C. Design activities undertaken by individual identified in Section B. [Building Code Table 3.5.2.1 OF Division C]			
☐ House ☐ Small Buildings ☐ Large Buildings ☐ Complex Buildings ☒ HVAC – House ☐ Building Services ☐ Detection, Lighting and Power ☐ Fire Protection ☐ Building Structural ☐ Plumbing – House ☐ Plumbing – All Buildings ☐ On-site Sewage Systems			
Description of designer's work HEAT LOSS / GAIN CALCULATIONS DUCT SIZING RESIDENTIAL MECHANICAL VENTILATION DESIGN SUMMARY RESIDENTIAL SYSTEM DESIGN per CSA-F280-12		Model: 2008 Lawson Project: CENTREFIELD (WEST GORMLEY)

City of Richmond Hill
Building Division

HVAC REVIEWED

Building Permit #: **BP#-2021-50733**

BASEMENT PLAN, EL. 'A' & 'B'

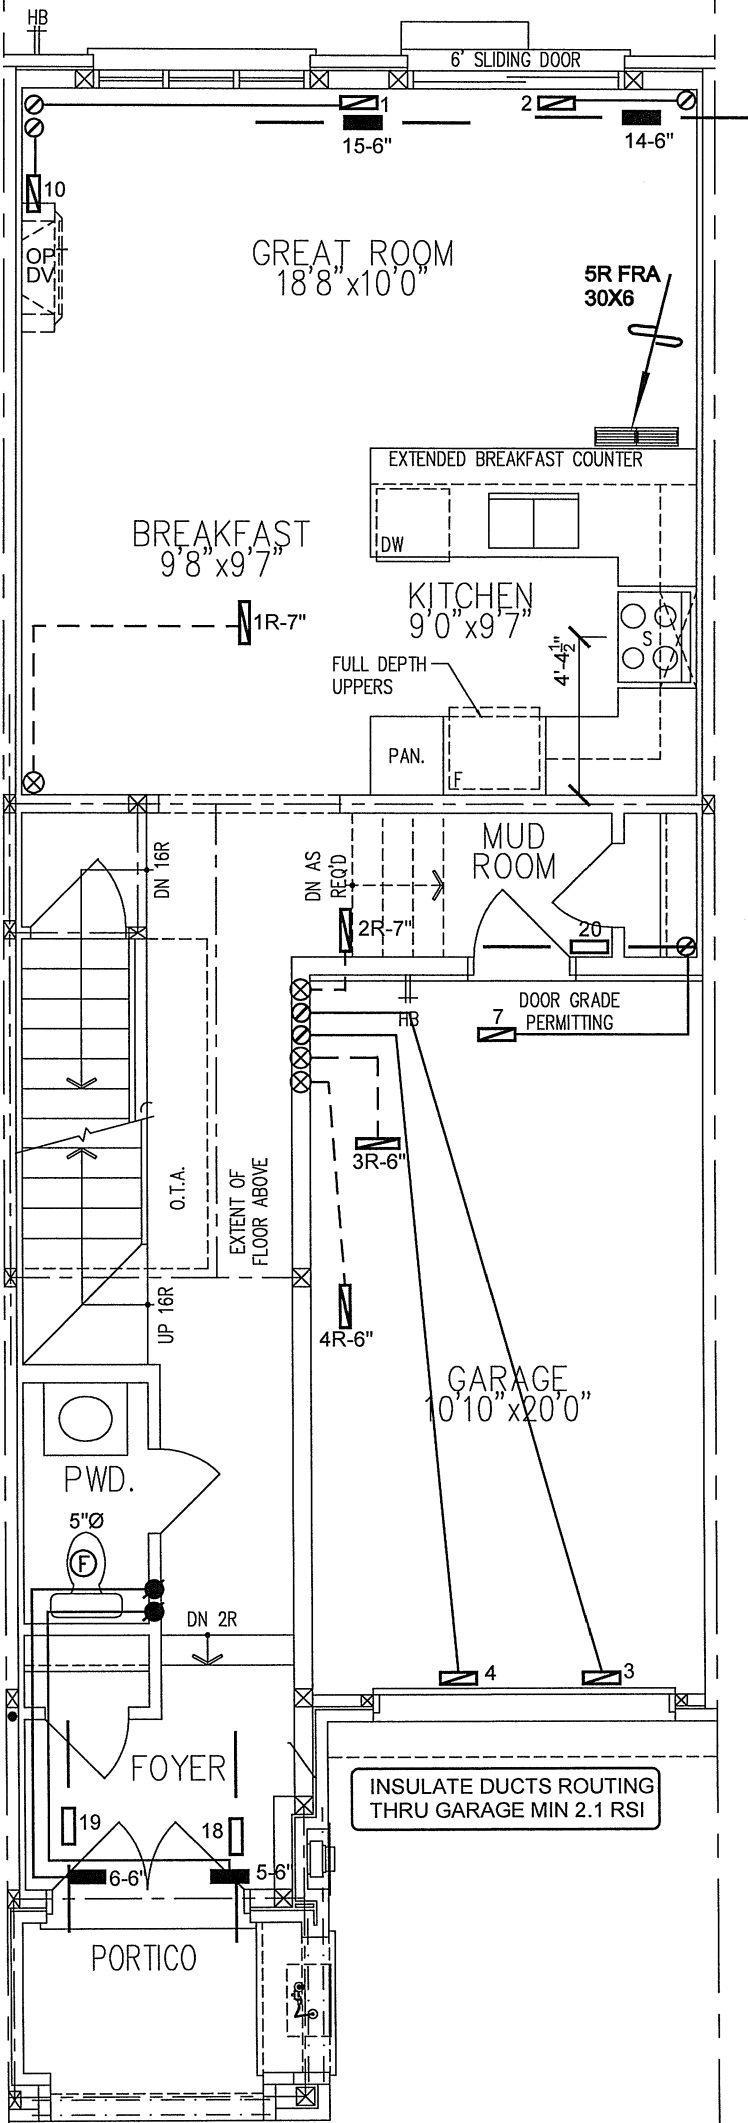
Ensure that R-Values and U-Values used for heat loss and heat gain calculations are consistent with the values specified by SB-12 Performance Compliance: **Energy Modeling/air leak test** and the values used for architectural design.

Minimum R-12 Insulation Value required for ducts installed at unheated or exposed condition (OBC 2012 Div.B 6.2.4.3(10) and seal the ducts as per 6.2.4.3(11) & HRAI Digest 2005, Clause 4.5.

Penetration of Air Barrier System by ducts, wires, conduits or building materials shall be sealed as per OBC 2012, Div.B 9.25.3.3.(9) & (10).

Volume control dampers to all branches to be installed per OBC 2012, Div.B, 6.2.4.5.

Space between studs and joists used as return ducts shall be separated from unused portion as per OBC 2012 Div.B 6.2.4.7(6)

Combustion air supply shall be provided to the furnace and hot water tank.

HRV installation, testing, startup and commissioning shall be in compliance with OBC 2012, Div.B 9.32.3.11, 9.32.3.11(7)&(10)

HRV duct connection shall be in compliance with OBC 2012 Div.B 9.32.3.6(3) & 9.32.3.4(7).

Supply air grill at finished basement shall be at low level. Return air grill for finished or unfinished basement shall be at low level. HRAI digest 2005, clause 7.7(3).

Air supply outlet shall not be installed on a furnace plenum or trunk duct. (HRAI Digest 2005, 4.6)

Exterior insulation effective R-Value for wall, roof or exposed floor shall be maintained at the respective location where duct or sanitary pipes are routed inside exterior envelope.

Return air intake shall be provided as recommended in HRAI Digest 2005 Section 4.7 Return air inlet should be positioned so that short circuiting of supply air is avoided. A high and low wall return air combination shall be provided when a combined cooling & heating system is installed.

HRV Unit shall be energy qualified complete with sealed and insulated connection to outdoor vent hoods per Energy Star Technical Specification 4.7.1.2. When HRV is used as principal fan, the controller shall be wired to the HRV Unit and interconnected to the furnace fan. HRV shall be designed for operation at outside temperature of -25°C and a flow of minimum 30 L/s (64 CFM)

For simplified HRV/ERV installation, with stale air and fresh air connected to return air plenum, stale air intake and fresh air supply shall be separated minimum 3' or as recommended by HRV/ERV Manufacturer.

GROUND FLOOR PLAN, EL. 'A'

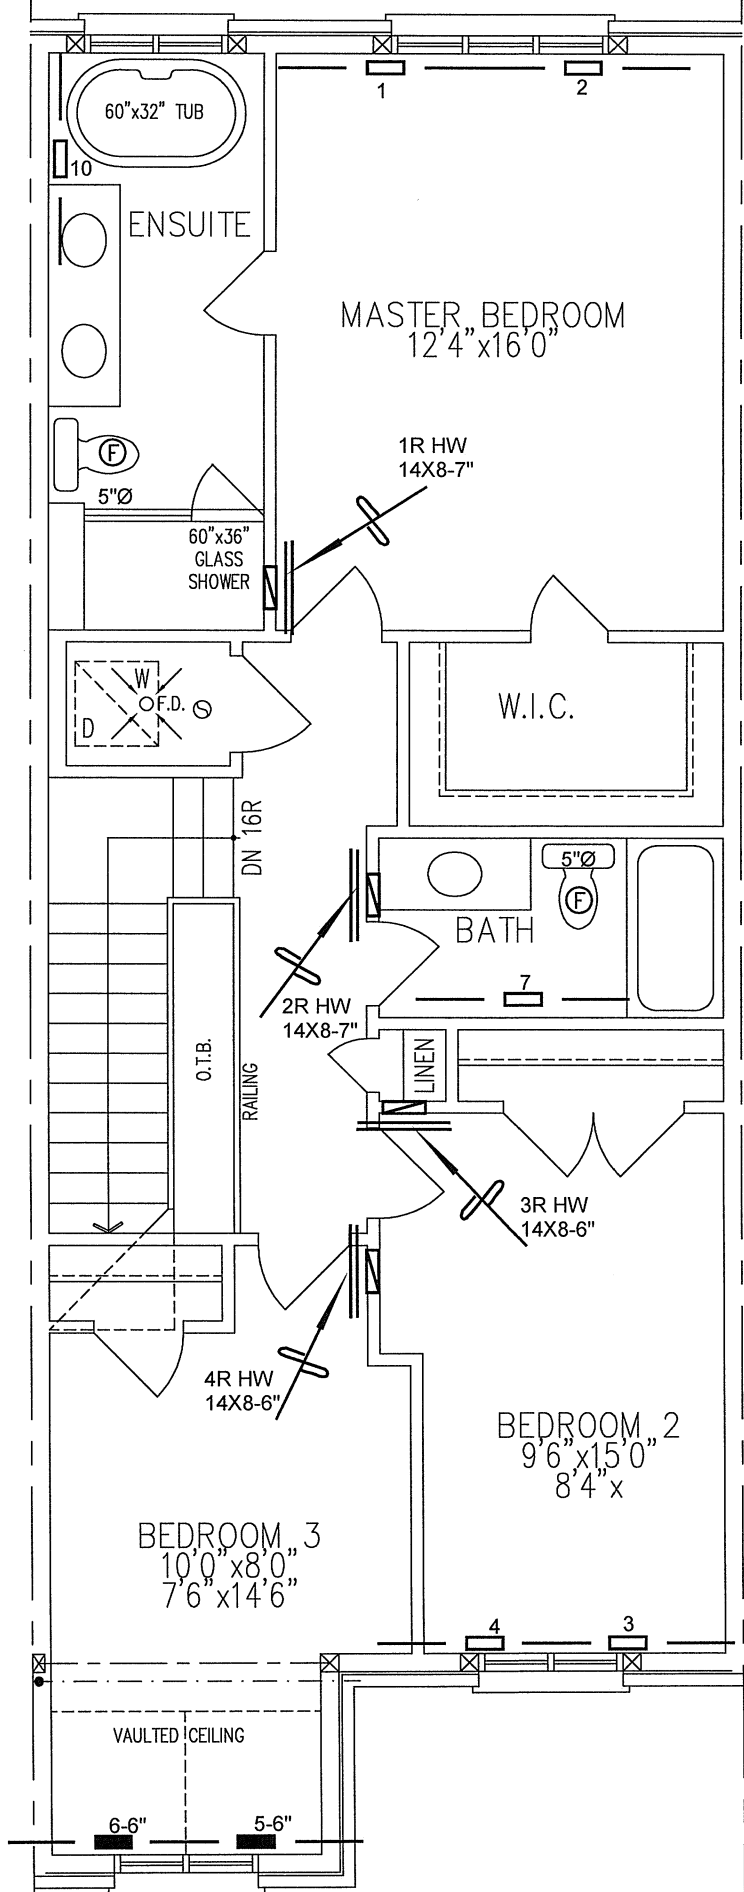
Space between studs and joists used as return ducts shall be separated from unused portion as per OBC 2012 Div.B 6.2.4.7(6)

Exterior insulation effective R-Value for wall, roof or exposed floor shall be maintained at the respective location where duct or sanitary pipes are routed inside exterior envelope.

Kitchen hood exhaust duct shall be provided as per OBC 2012, Div.B 9.32.3.10, 9.32.3.5(2).

SECOND FLOOR PLAN,
EL. 'A1/A2'

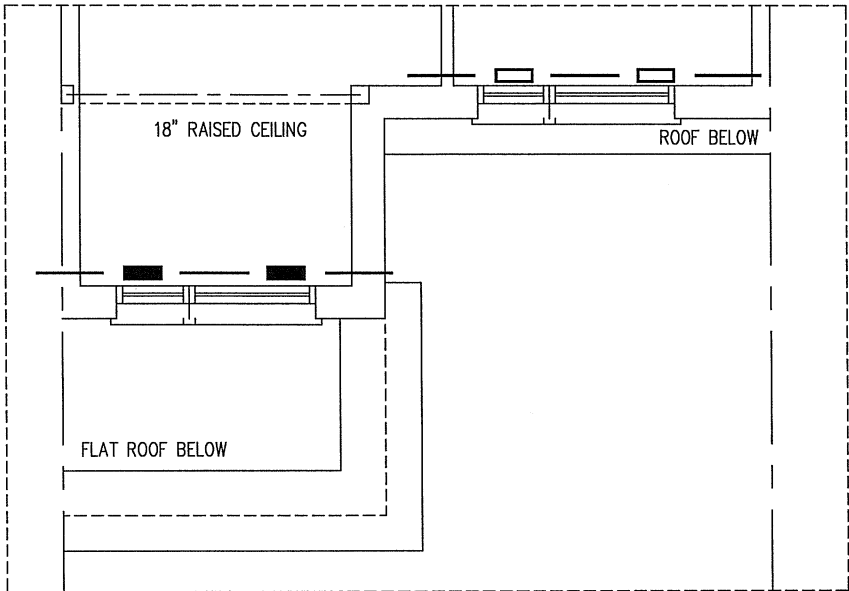
Space between studs and joists used as return ducts shall be separated from unused portion as per OBC 2012 Div.B 6.2.4.7(6)

Laundry dryer exhaust duct shall be provided as per OBC 2012 Div.B 6.2.3.8(7).
